Sydenham to Bankstown Metro: Key issues and opportunities

December 2017

Endorsed by Council 28 November 2017

The City of Canterbury Bankstown (Council) provides comment on the Metro Southwest EIS to highlight the significant city shaping opportunities that would be missed if the current plan was constructed as proposed.

Figure 8 Sydney Metro City & Southwest – Sydenham to Bankstown upgrade EIS, September 2017

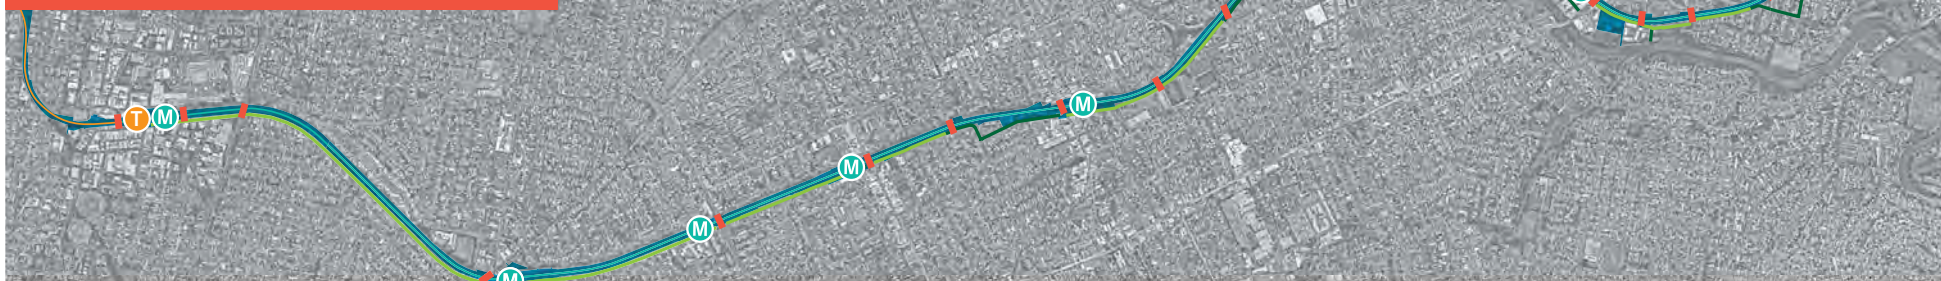
Each station should be designed with the principle that users are catered for in the following order with the first being located closest to the station entry and the last furthest from the entry (see Figure 8):

1. Pedestrians;
2. Cyclists;
3. Buses;
4. Disability parking spaces;
5. Taxis and other ride-hailing services;
6. Delivery vehicles; and
7. Private vehicles.

Figure 2 Key opportunities and gaps – Bankstown Station Underground Scenario

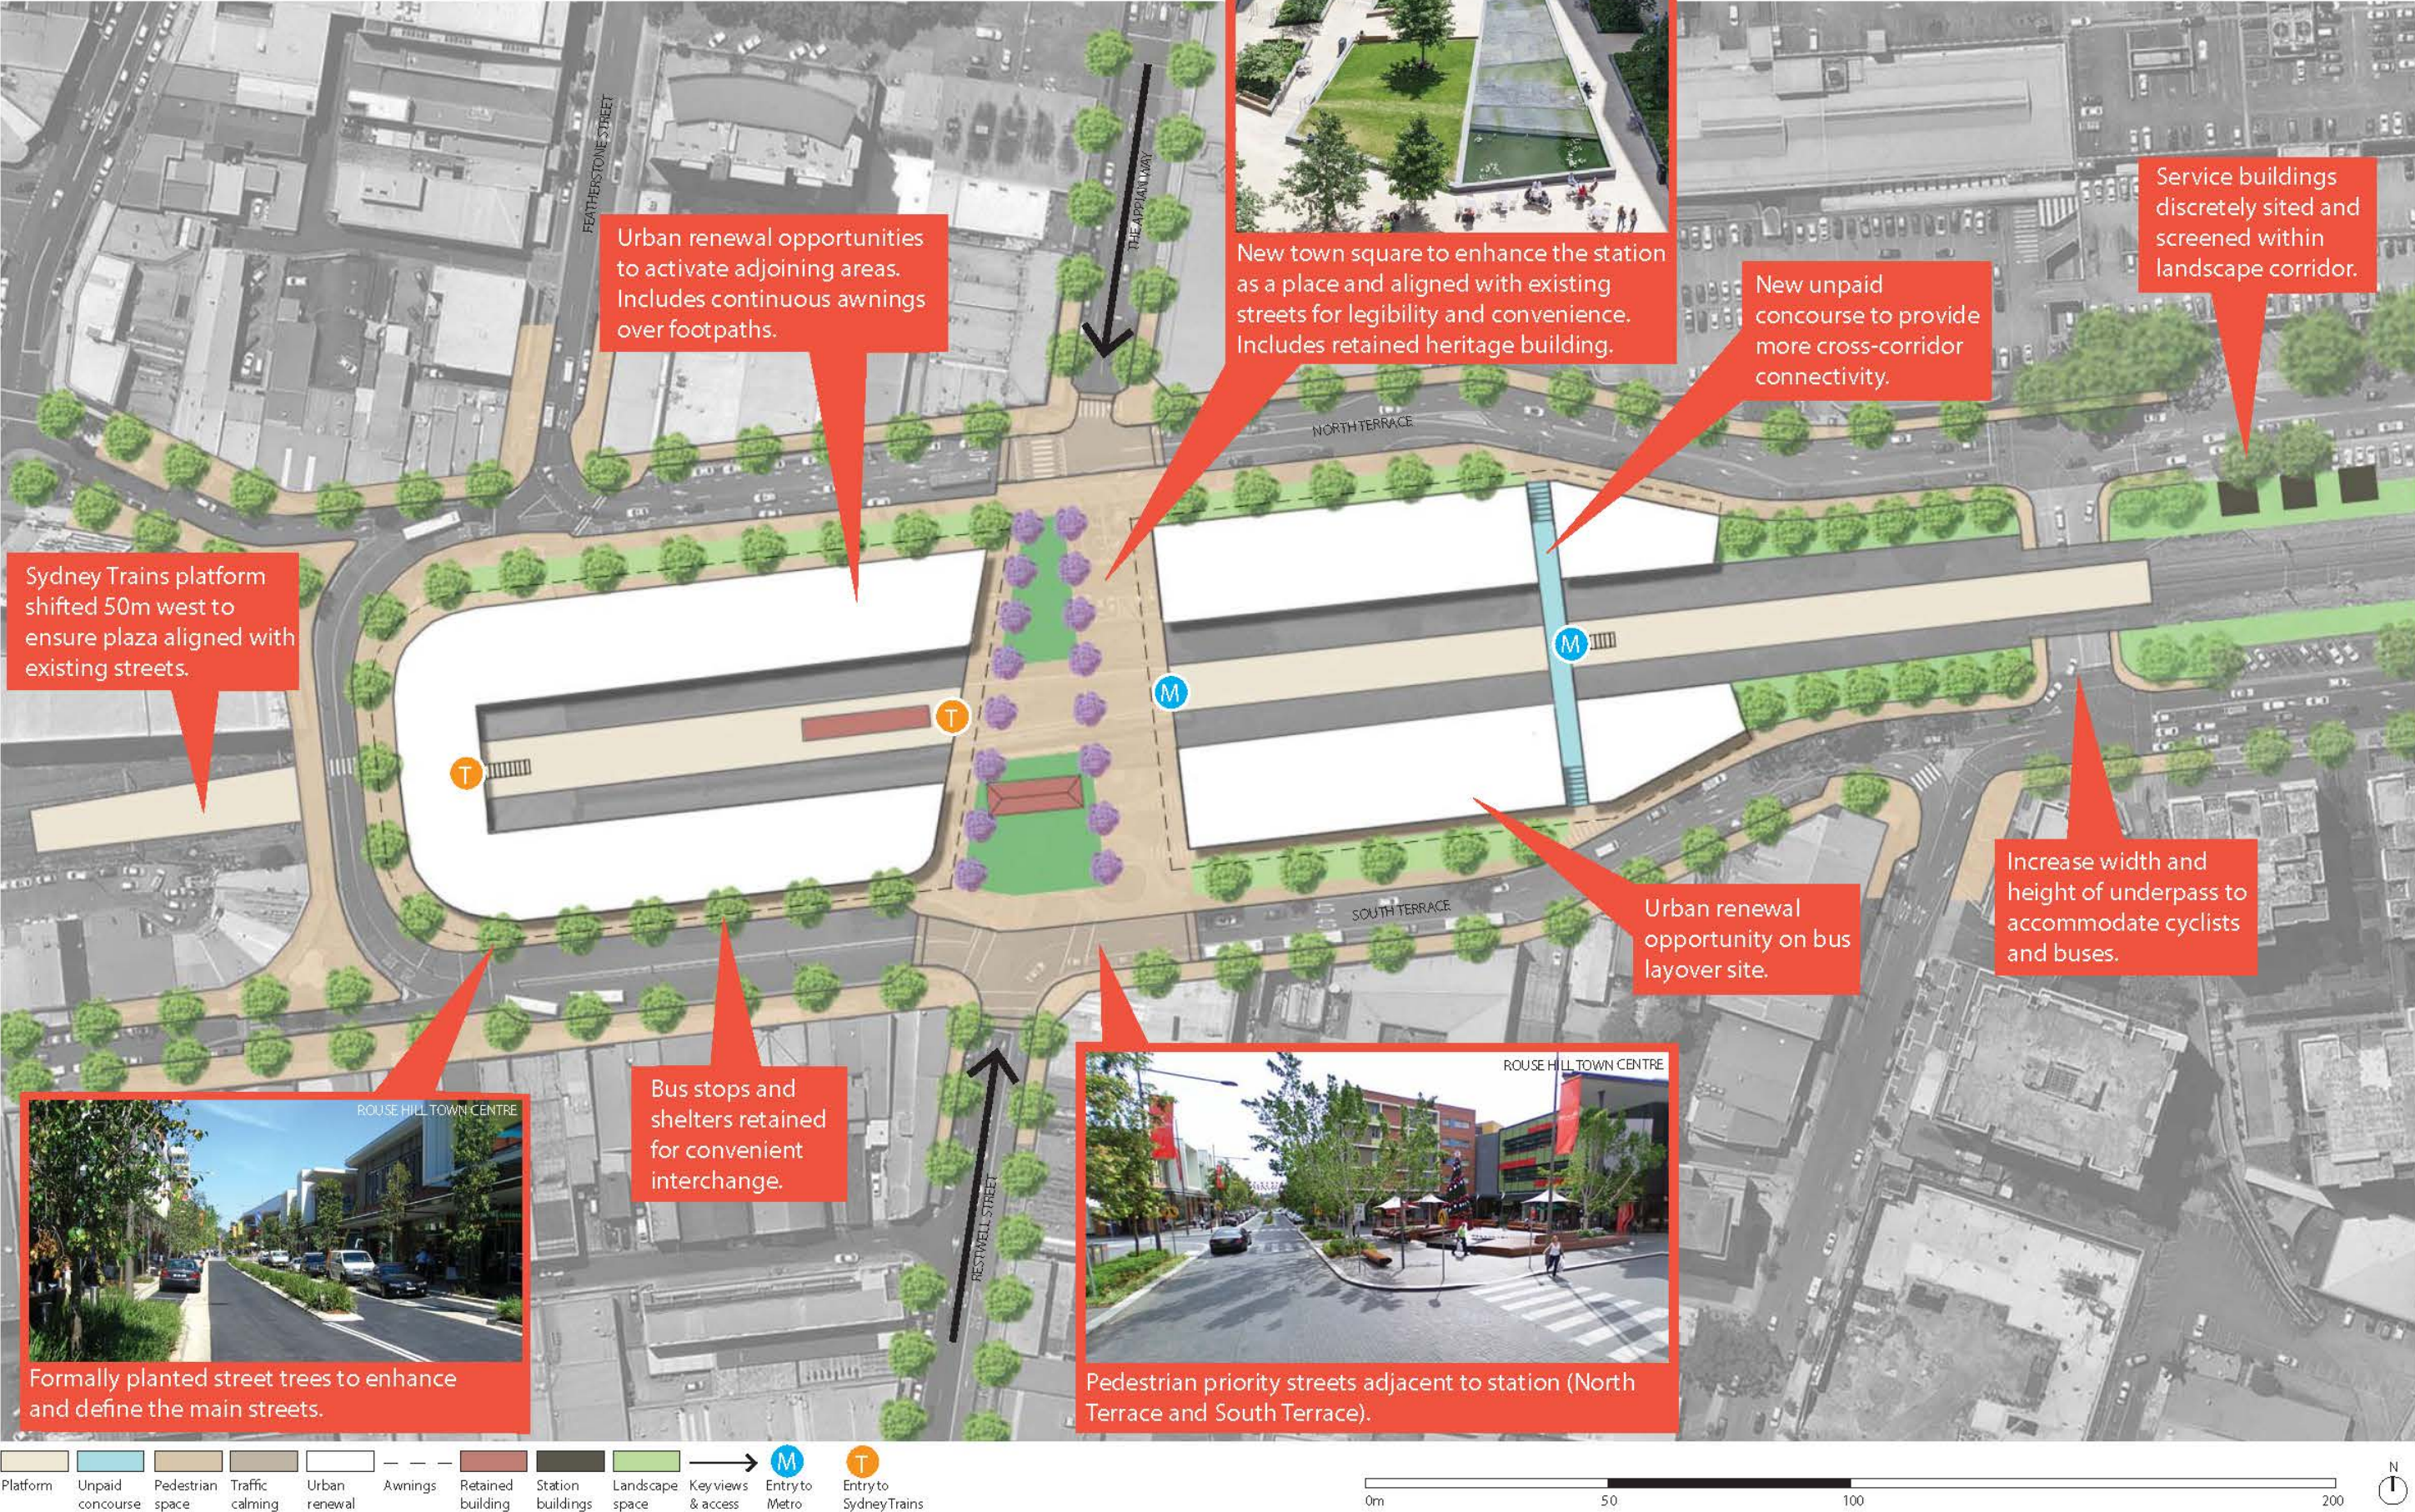
At a minimum in an above ground configuration, an unpaid concourse should create a legible connection from The Appian Way north of the Metro to Restwell Street south of the corridor. An option may be to shorten (due to shorter trains travelling west), or extend the train platform to the west but this is not discussed in the EIS. However, Council firmly assert this new connectivity point must be delivered as a public space. Illustrations of these concepts are provided in Figure 2 and 3.

Figure 5 Key opportunities and gaps –
Punchbowl Station above ground

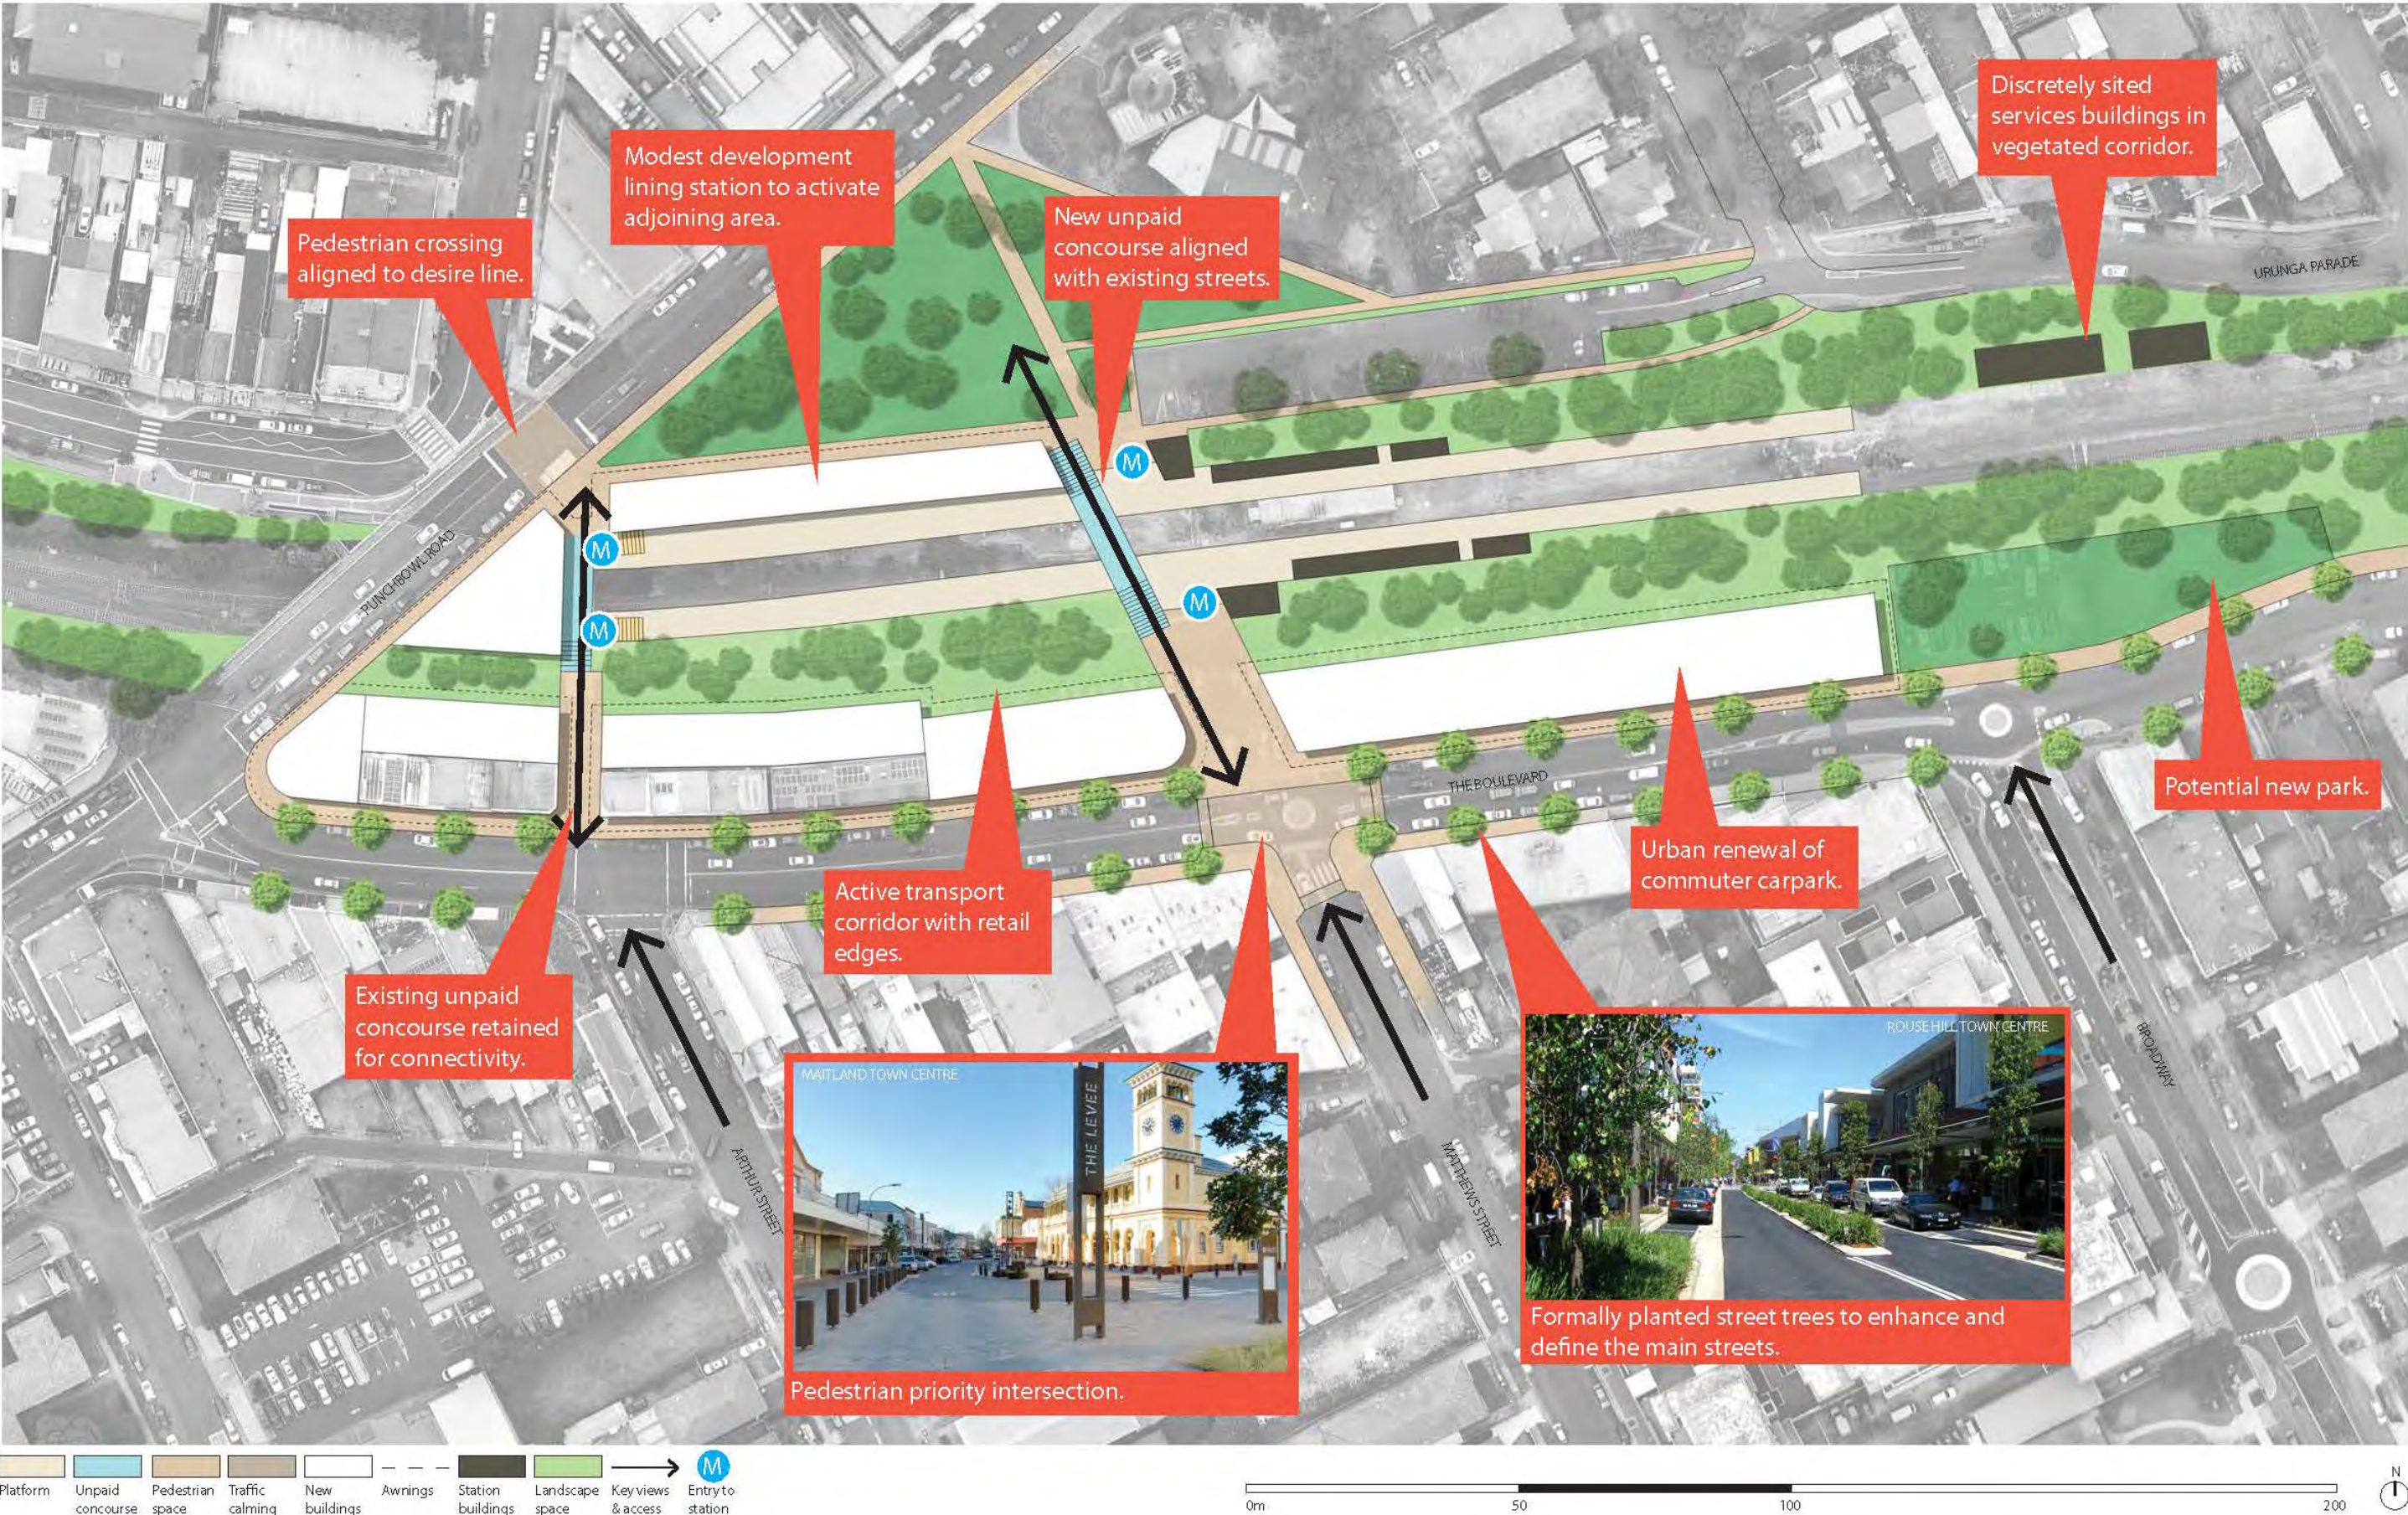
This section provides two maps showing opportunities for Punchbowl Station. One map shows an undergrounded Metro line (Figure 4), which is Council's preference, and the other map shows preferred improvements if the Metro is retained above ground (Figure 5). Following the maps are tables describing the opportunities in detail and the relevant *Better Placed* principles they address.
